ENGINE - AIR - INTRODUCE A NEW BRACKET AT CLIPPING POINT 5560 - CATEGORY CODE 7 -  
CATEGORY CODE 6 - MOD.ENG-75-0044

V2500-ENG-75-0044

Location of harness bracket  
Fig.1

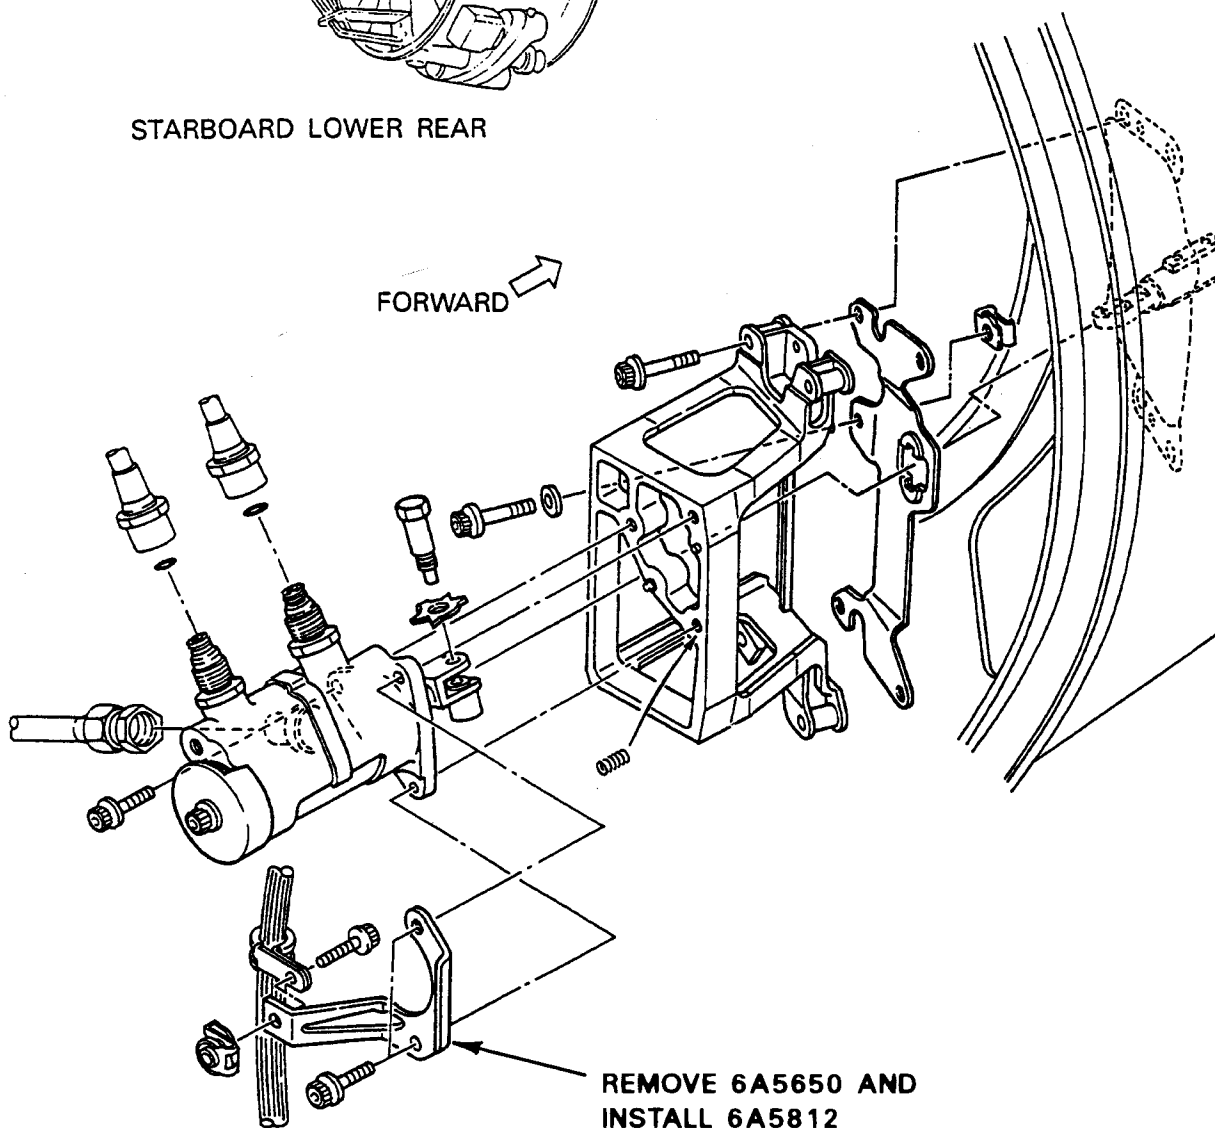
This Service Bulletin introduces a new support bracket to provide increased clearance for the clip. Existing brackets can be reworked.

View on fan frame at B.S.B.V. slave actuator showing location of modified bracket -  
Before and after alteration  
Fig.2

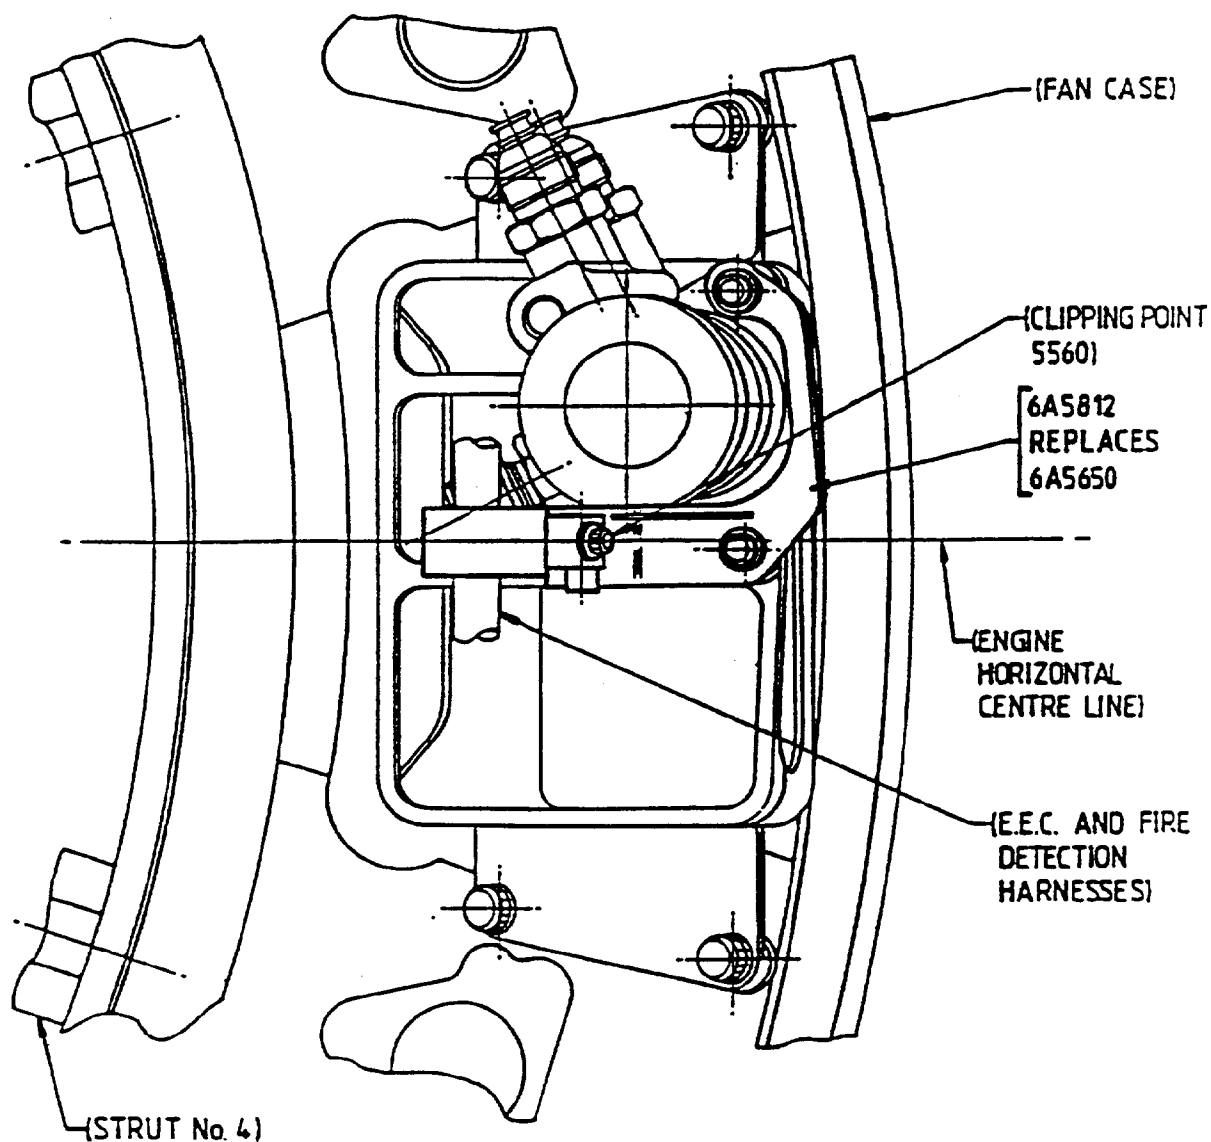
There is insufficient clearance between the support bracket and harness clip at clipping point 5560.

View showing reworking of existing brackets  
Fig.3

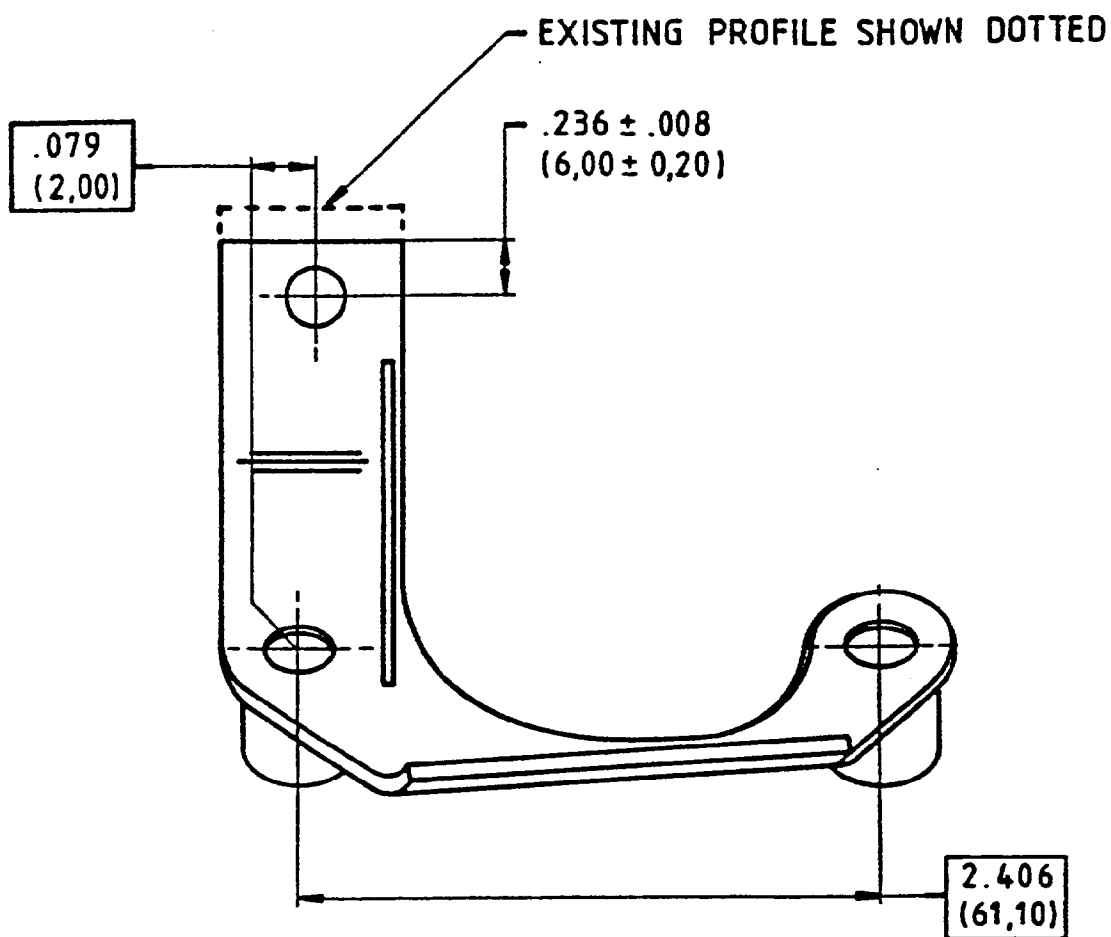
PROCEDURE	SUPPLEMENTARY INFORMATION
(a) Chemically clean the support bracket	Refer to SPM TASK 70-11-03-300-503 Use chemical cleaning equipment.
(b) Mark the rework area	Refer to Figure 3. Use a locally manufactured template with a scribing tool
(c) Remove the unwanted material	Refer to Figure 3. Use standard workshop equipment
(d) Remove burrs and break sharp edges	Use standard workshop equipment
(e) Visually examine and measure the dimensions of the support bracket	Refer to Figure 3. Use standard workshop equipment
(f) Cancel the existing part number and identify with the new part number	Refer to SPM TASK 70-09-00-400-501, SUBTASK 70-09-00-400-001. Existing                      Re-number 6A5650                      6A5812  Use vibro-engraving equipment

INCHES (MILLIMETRES)  
REMOVE BURRS AND BREAK SHARP EDGES
